RIGOH	Technical B	Bulletin	No.	F/LX7 - 001
SUBJECT: ADF Mylar				<b>DATE:</b> 1996. 10. 30.
PREPARED BY: K. Misugi CHECKED BY: S. Fujii		FROM: 2nd	d Field Ir	nformation Group, QA Division
CLASSIFICATION:  Action Required Troubleshooting Retrofit Information	Revision of servi Information only Other			l FAX1700L 1765, SAVIN FAX 3650

Model: F/X7			Date: 15-1	eb-97	No: 002	<b>1</b> /5
Subject: FX7 Sei	vice Manual Correction			Prepared	d by: K.Misugi	
From: 2nd field Ir	formation Group, QA Division			Checked	l by: S.Fujii	
Classification:	⊠Troubleshooting	⊠Pa	art informat	tion	Action required	
	☐Mechanical	□EI	lectrical		Service manual revision	n
	☐Paper path	□Tr	ransmit/rec	eive	Retrofit information	
	Other ( )

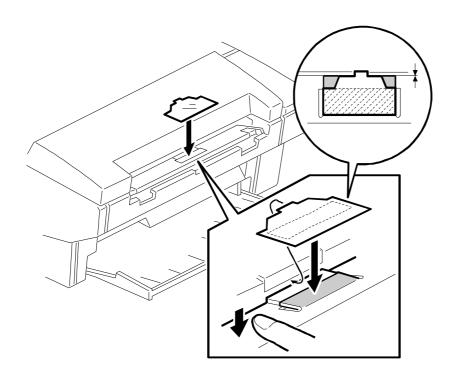
For customers who would like to use originals which contain silicone oil, place the mylar on the Document Separation Pad as shown in the diagram below.

The ADF mylar will be available as a service part.

Part Number: H528 9500

### **SOLUTION**

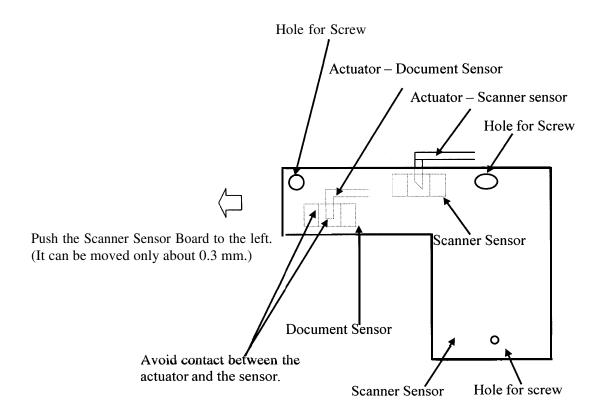
A document jam error occurs even though there are no documents in the ADF. This is because the Document Sensor is stuck.

The actuator of the document sensor touches the sensor unit on the Scanner Sensor Board.

If the document sensor does not return to the initial position, please do the following.

- 1. Loosen the screws of the Scanner Sensor Board.
- 2. Push the Scanner Sensor Board to the left side.
- 3. Tighten the screws.

1. Replace the Document Sensor Actuator.

H5291160: Actuator - Document Sensor

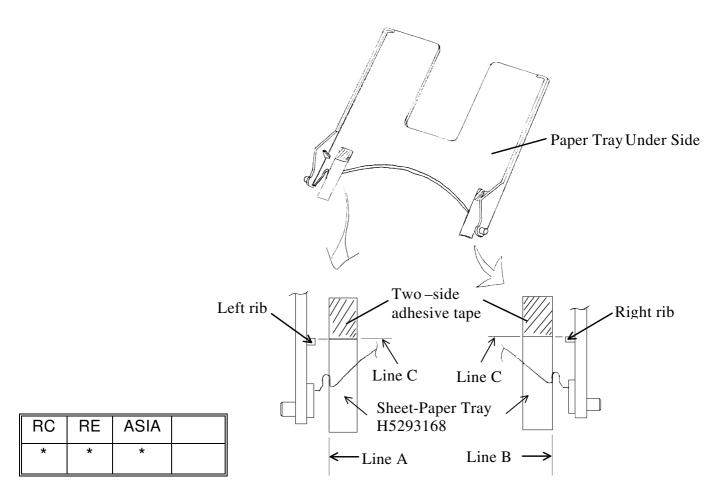
A paper jam occurs because the paper tray is in the wrong position.

Sheets have been added to the paper tray as a countermeasure to prevent the paper tray from being set in the wrong position. Please refer to the following installation procedure.

P/N: H5293168 (Sheet-Paper Tray)

- 1. Put two-sided adhesive tape on the underside of the paper tray near the hinges along the Line A and B and Line B and C as shown below.
- 2. Press down on the adhesive tape after application to remove any air bubbles.
